Manly Independent Assessment Panel

Thursday 17 June 2010

TO: Manly Independent Assessment Panel - 17 June 2010
REPORT: MIAP Report No. 31
SUBJECT: 11 Edwin Street, Fairlight - DA5/10
FILE NO: DA5/10

DRAWING: FIRST FLOOR PLAN

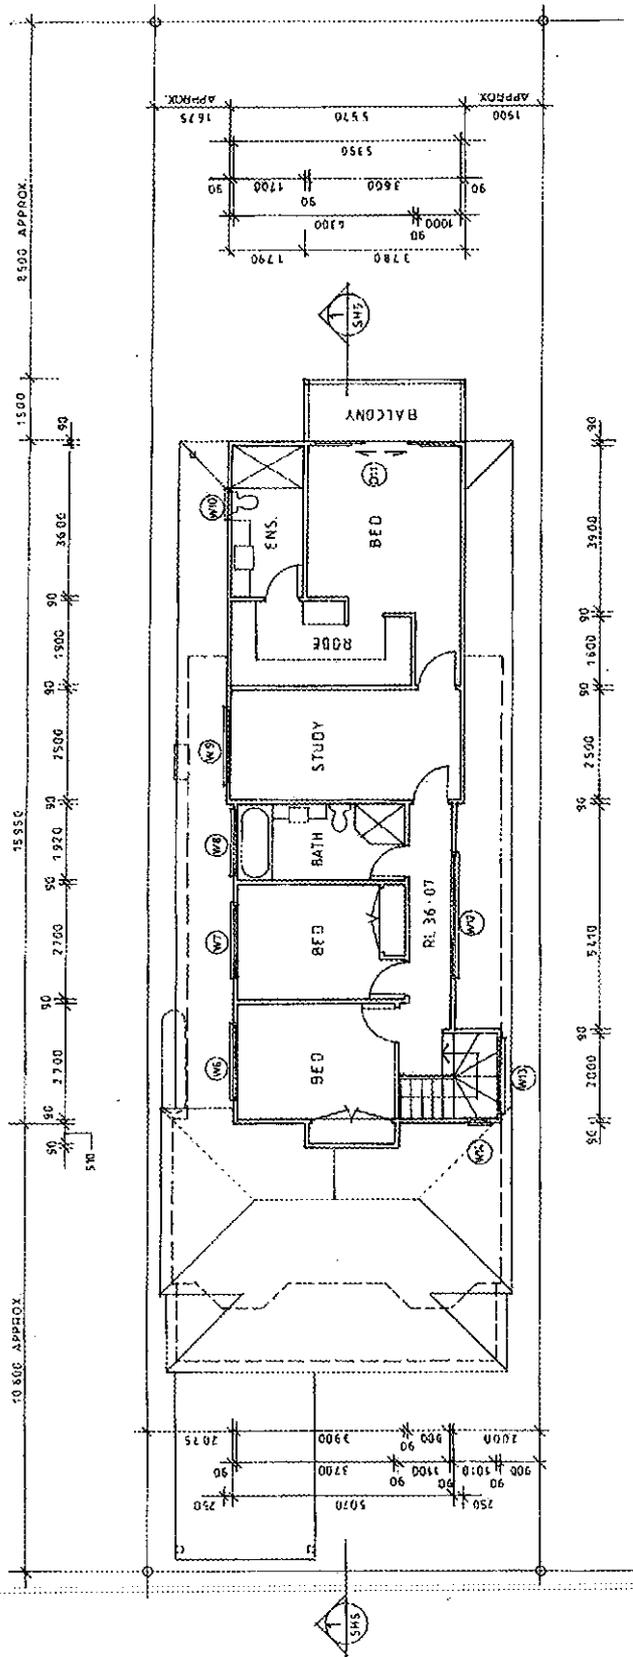
The side setbacks to the east on the first floor level has one portion of the wall with a stated setback of 1.675m where 1.87m would be the 1/3 wall height requirement. It is considered that while the floor plan could be changed to fully comply, the step in the wall length breaks up the apparent length of the wall and is appropriate. It is also noted that the roof form is continuous so that this reduction of setback does not increase the shadowing over the neighbour.

The side setbacks to the west on the first floor level has one portion of the wall associated with the stair well with a stated setback of 0.900m however this section of wall is only 2.2m wide and can be considered favourably given the functioning of the floor plan.

The proposed first floor balcony off the master bedroom has been subject to criticism by the objectors as there is a clear line of sight into the neighbour's yards from this elevated position. The applicant has advised that their client would prefer the screens to the sides as drawn however are prepared to provide a 1.6m high privacy screen all around to facilitate approval. The semi enclosure of the balcony would take the floor space ratio to 0.62:1 which is 5m² above the recommended figure. It is noted that the balcony is 8.8m from the rear boundary which is almost the 9.0m referred to in the AMCORD standards as an adequate separation for privacy. It is therefore considered that a solid balustrade would prevent the clear line of sight view while still allowing for the amenity of a balcony.

The plans indicate an air conditioning plant between the eastern wall and the adjacent boundary which could result in disturbance to the adjacent neighbour. A condition is therefore suggested relocating this air conditioner to the southern elevation of the dwelling where any maintenance and noise issues would be apparent to the owners. A condition to this effect is included in the recommendation.

The elevated nature of the balcony and the ability to see into the rear yards of all surrounding properties was discussed with the applicant who submitted a letter to Council suggesting they could if required construct a 1.6m high screen around all sides of the proposed balcony rather than the 1.7m screen to the east and west sides as illustrated on the plans. It is considered that such a screen would add to the bulk of the building and that it would amount to additional floor space and is not supported.

As an alternative a condition is suggested requiring a solid balustrade to provide adequate privacy having regard to the distance between the balcony and the rear boundary.

The proposed balcony off the bedroom at first floor level is to be provided with a solid balustrade in order to ensure privacy to surrounding residents and the roof form over this balcony is to be changed to a flat roof to reduce early morning overshadowing of the adjoining property to the west in mid winter. In this regard the plans are to be amended accordingly prior to the release of the Construction Certificate.

The air conditioning plant is to be relocated on the southern wall of the ground floor. In this regard the plans are to be amended accordingly prior to the release of the Construction Certificate.

WEST ELEVATION

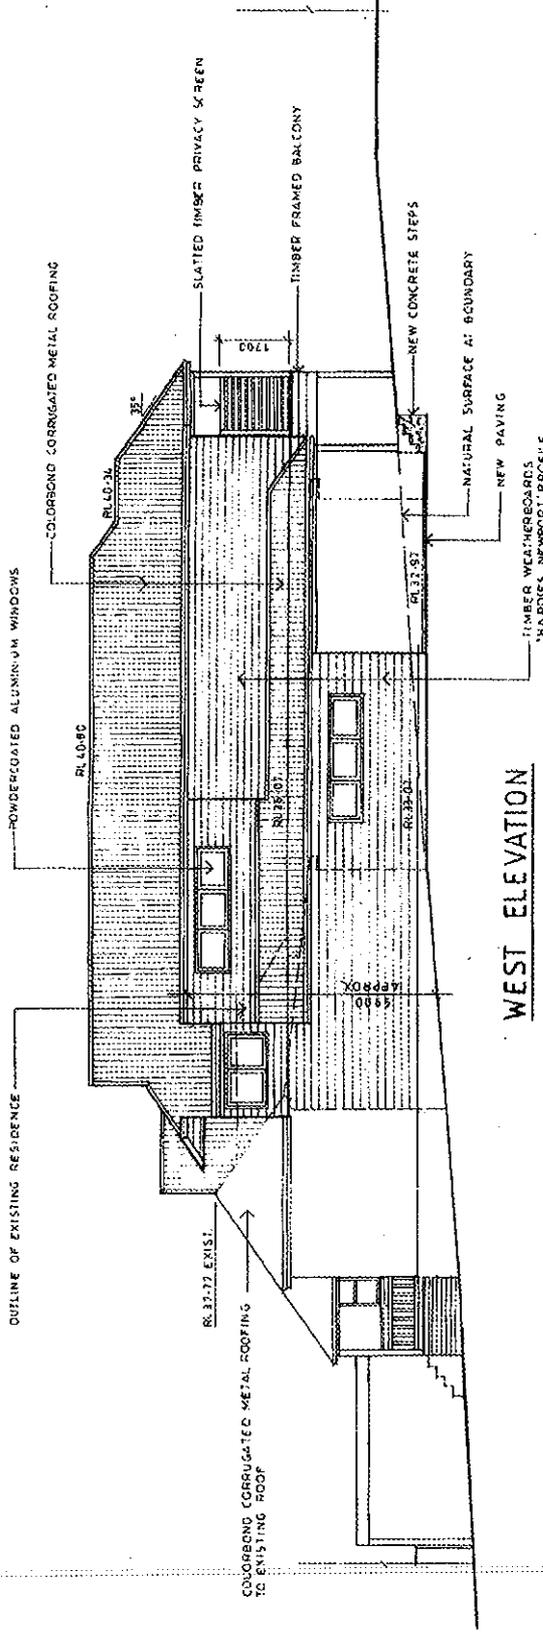
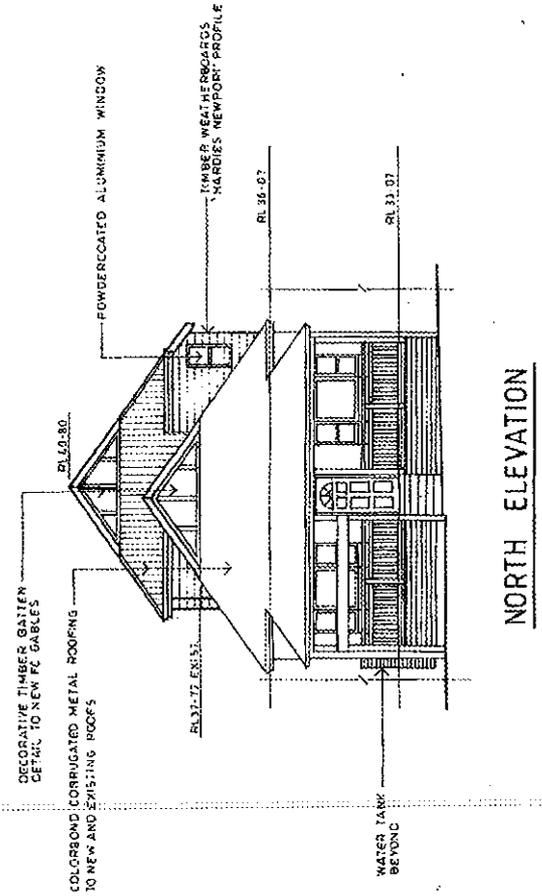
The roof form is to be lowered by 150mm resulting in an RL of the ridge of RL40.65 and the plans are to be amended accordingly prior to the release of the Construction Certificate.
